New option – low-profile Hook Mount for Valor® light bars

Federal Signal announces that Valor® light bars can now be ordered with the new “**Low Hook**” low-profile, hook-on mount option.

Standard Hook Mount on a Ford® Police Interceptor Utility

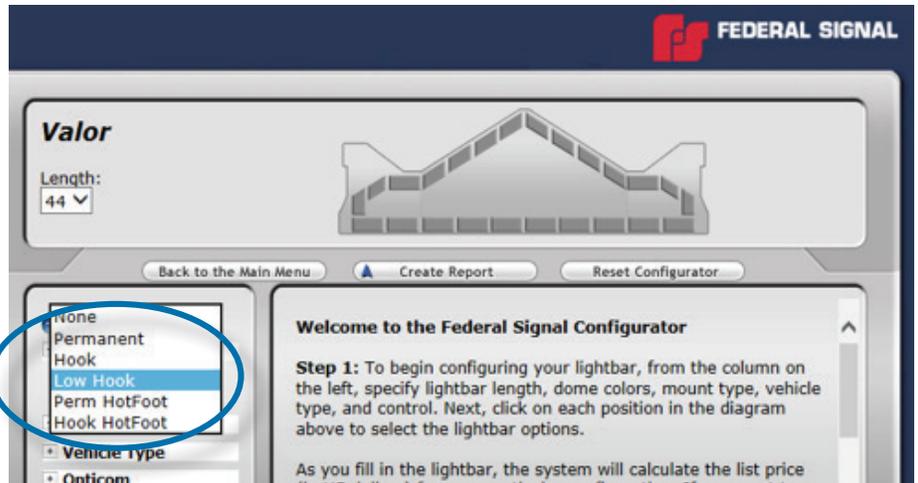
The new “**Low Hook**” option allows the body of the light bar to be approximately 7/8 of an inch lower than the standard “Hook” mount, depending on the specific vehicle make/model.

Low Hook Mount on a Ford® Police Interceptor Utility
